ABBOTT ADD	INDEX INSTRUMENT SERVICE ADVISORY
--	--

PRODUCT: ALCYON (TM) 300i Rev 1 (120)	DATE: 17-AUG-1999
---	-----------------------------

SUBJECT: Dual Voltage Heater	ISA#: 120-018
ORIGINATOR: Emil Jivan	PRODUCT: ALCYON® 300i Rev 1 (120)
APPROVED: Kathy Jennings 17-AUG-1999	EFFECTIVITY DATE: 17-AUG-1999

Figure 1

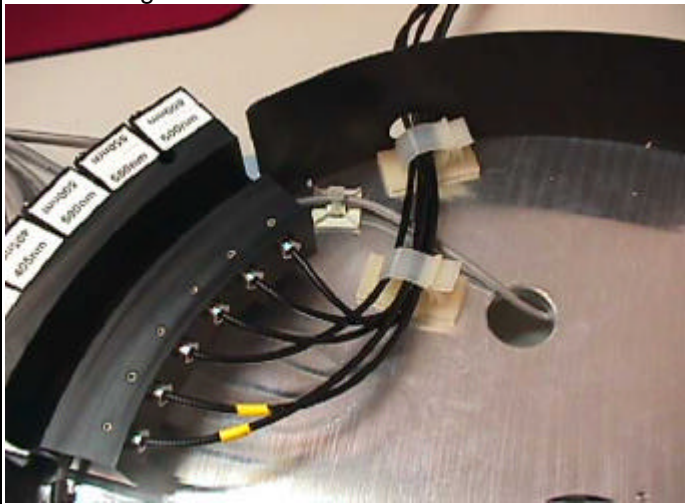
Action		Comments
Removing Old Heater Assembly		
1	Remove all Patient Samples from Sample Carousel.	
2	Perform the Short Term Shutdown found in VP-01.	
3	Perform RR-C1.13 to remove old Heater Assembly.	Unplug Heater Assembly Cable (P203, W23) from the back of the instrument prior to removing Heater Assembly.
Heater Resistance Verification		
1	Check the resistance between the two wires, labelled P184 pin 3 and P120B RLY. Verify that the resistance measures between 76 and 84 Ohms.	
2	Check the resistance between the two wires, labelled P184 pin 4 and P121B RLY. Verify that the resistance measures between 76 and 84 Ohms.	
Installing New Heater Assembly		
1	Perform RR-C1.13 in reverse order to install the new heater.	During installation add an additional Cable Clamp to keep Colorimeter Cables away from the heater. Verify that the cables are not interfering with the heater. See Figure 1.

Figure 2

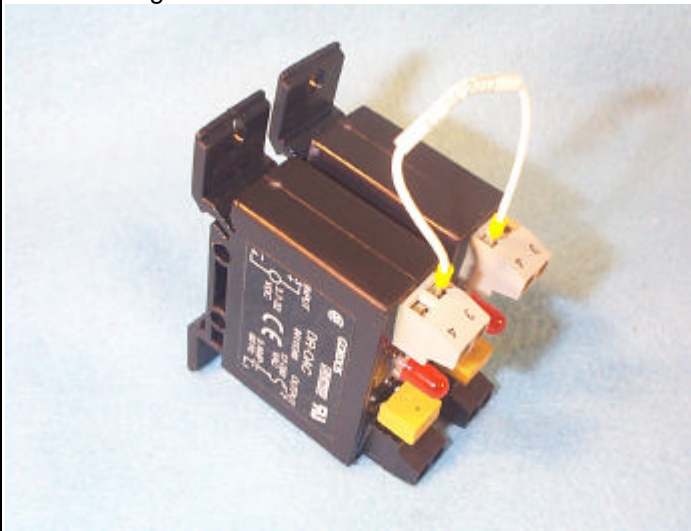
| 1 | Connect Jumper Cable between Terminal 3 of one Relay and Terminal 4 of the other Relay. Secure Cable by tightening the screws. | See Figure 2. |

Figure 3
Dual Heater Assembly Wiring Diagram

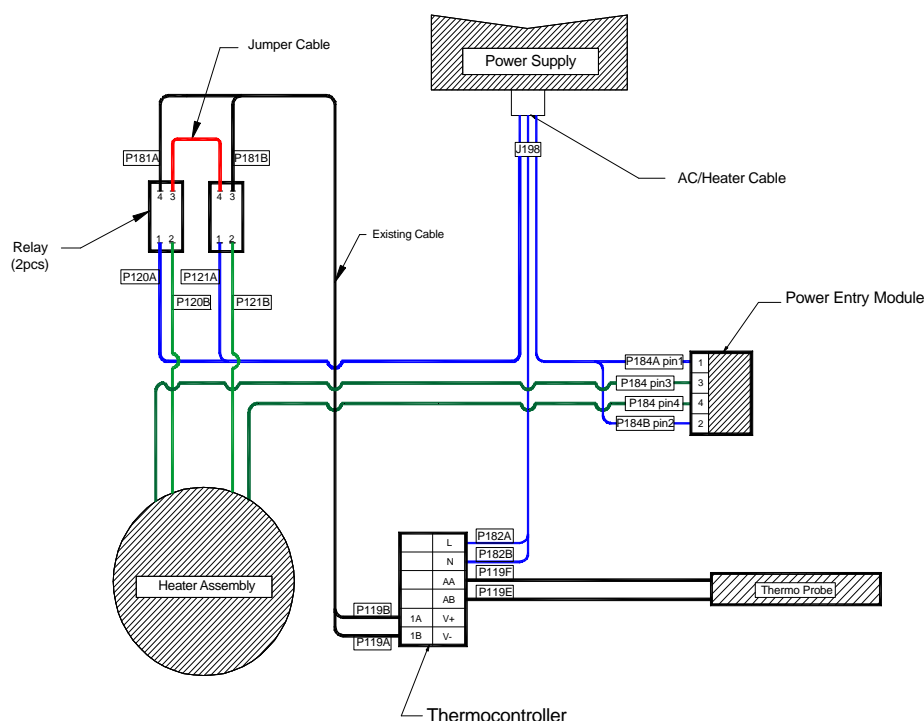
The new heater assembly works on both instrument configurations 110V and 220V. The new heater contains two separate elements of 80 ohms each. These elements can be thought of as resistors. The power entry module is used to connect the elements in either series or parallel. This creates the same nominal power in either configuration.

- 220V: with 220V connected
Elements are connected in series
Equivalent resistance value of 160 ohms
Nominal power of 302 W.
- 110V: with 110V connected
Elements are connected in parallel
Equivalent resistance value of 40 ohms
Nominal power of 302 W.

| 2 | Connect AC/Heater Cable J198 to Power Supply and then secure it with a Tie Wrap around the connectors. See Electrical Schematic in Figure 3. | Verify connection by slightly pulling the cable. |

Terminal P184A pin1 to Position 1 of PEM
Terminal P184B pin2 to Position 2 of PEM
See Electrical Schematic in Figure 3. | |

1	<p>Connect Heater Assembly Cables to Both Reaction Temperature Relays as follows:</p> <p>Terminal P120B to Position 2 of the Left Relay</p> <p>Terminal P121B to Position 2 of the Right Relay</p> <p>See Electrical Schematic in Figure 3.</p>	Both Relays have position 2 located at the right - bottom of the Relay.
2	<p>Connect Heater Assembly Cables to Power Entry Module (PEM) as follows:</p> <p>Terminal P184 pin3 to Position 3 of PEM</p> <p>Terminal P184 pin4 to Position 4 of PEM</p> <p>See Electrical Schematic in Figure 3.</p>

Screen Changes to accommodate updated ISE Maintenance procedures

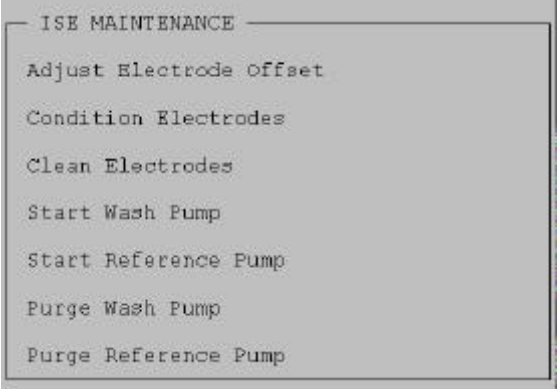
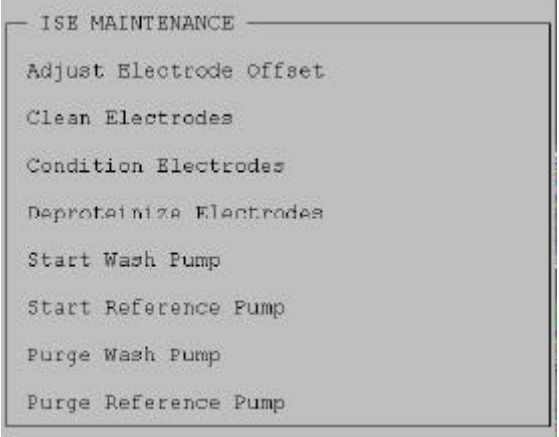
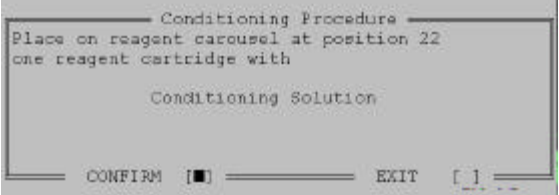
Version 1.5	New Version 1.6
<p>Screens do not appropriately accommodate updated ISE Maintenance procedures.</p> <p>Old screen:</p> 	<p>Screen changes to accommodate changes to updated ISE Maintenance procedures.</p> <p>New Screen:</p>  <p>Each option uses a single large container.</p>  <p>Timing is increased from 10 to 20 seconds so only one cycle needs to be performed.</p>

SIDs do not increment correctly when using leading zeros in the Batch Mode

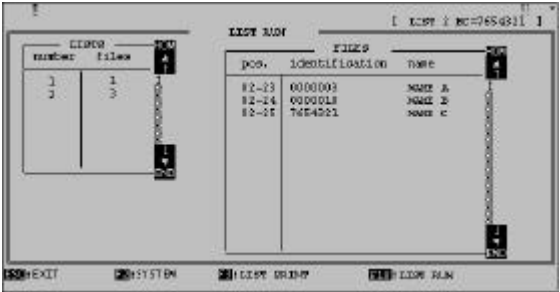
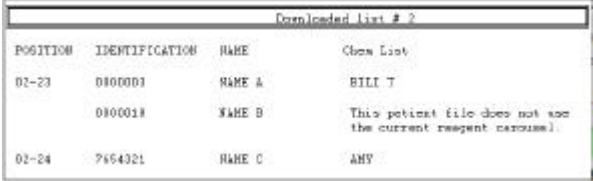
Version 1.5	New Version 1.6
SIDs did not increment correctly when using leading zeros in the Batch Mode. Zero was removed from all but the first SID.	<p>Able to use leading zeros in batch mode. Zeros are seen as significant characters and will not be removed in the Worklist.</p>

LIS Mode Screen displays incomplete message at top of screen

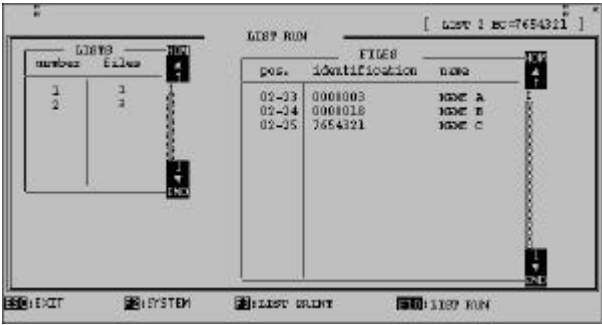
Version 1.5	New Version 1.6
LIS Mode screen displays an incomplete message at the top of the screen. Example: "Sample position statu"	Entire message will be displayed. Example: "Sample position status"

Improved Sample Probe Clamp

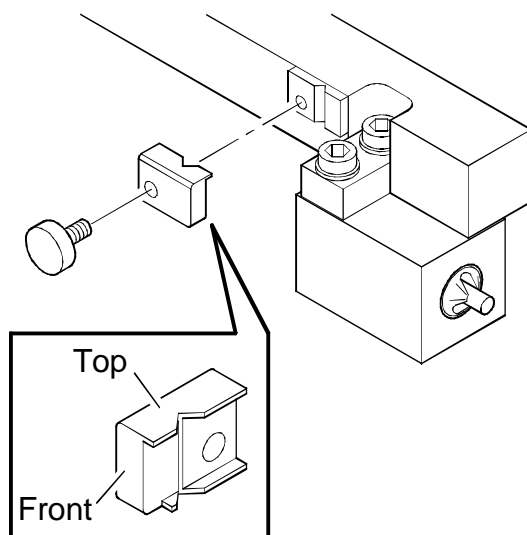
A new Sample Probe Clamp is being implemented. The new clamp improves the clamping of the Sample Probe which provides for a more consistent mixing action, especially when the probe is removed and reinstalled or replaced.

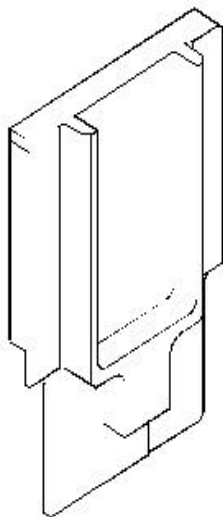
A new cast aluminum Cuvette Loader Assembly has been incorporated beginning with S/N 1696.

Changes to the assembly include the following:

- Cast aluminum frame - eliminates need to adjust rails
- New unload hook assembly - more reliable
- Knurled knob at motor for manually raising and lowering cuvettes when motor is disengaged
- New motor and motor is relocated lower on assembly
- Power resistor added to accommodate new motor
